Work Order ID 140498

Item Name: Fwd Crosstube - Mid Height 206L / L1 / L3 / L4

DRAWING NO. D206-667-147
REV. A
SHEET 1 OF 4
TITLE CROSSTUBE ASS'Y (206L MID FWD)
SCALE NTS

DRAWING NO. D206-667-147	TITLE CROSSTUBE ASS'Y (206L MID FWD)	REV. A	DART AEROSPACE LTD ENGINEERING ORDER		D.E.O. NO. D206-667-147-A-1	SHEET NO. SHEET 1 OF 1	SCALE NTS
DRAWN <i>Q2</i>	CHECKED <i>AS</i>	MFG. APPR. <i>AS</i>	APPROVED <i>MD</i>		DE APPR. <i>MD</i>		
DATE 11.07.15	DATE 11.07.20	DATE 11.07.21	DATE 11/07/21		DATE 11.07.21

DETAIL P
BONDING STRAP INSTALLATION 2 PL

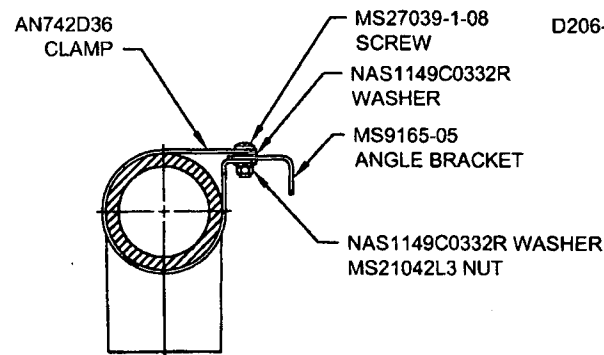
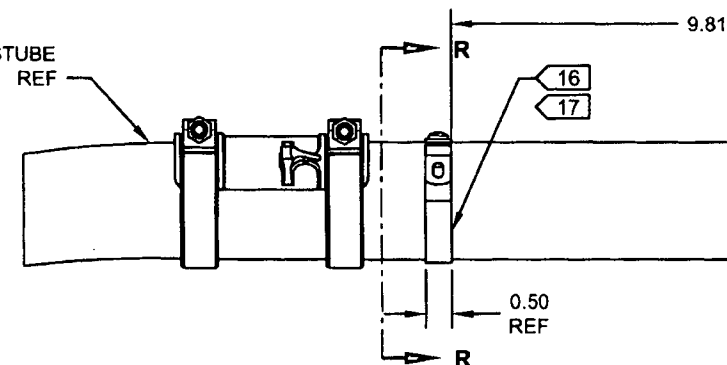
ADD ELECTRICAL GROUNDING STRAP

- 16) MASK AREA UNDER CLAMP PRIOR TO PAINTING
 17) SEAL EDGES WHERE AN742D36 CLAMP MEETS WITH THE CROSSTUBE USING SIKAFLEX-241/-291 OR MIL-S-8802 CLASS B2 OR PROSEAL 890 SEALANT
 18) PERFORM RESISTANCE CHECK TO ENSURE MAX RESISTANCE IS 10 MILLIOHMS
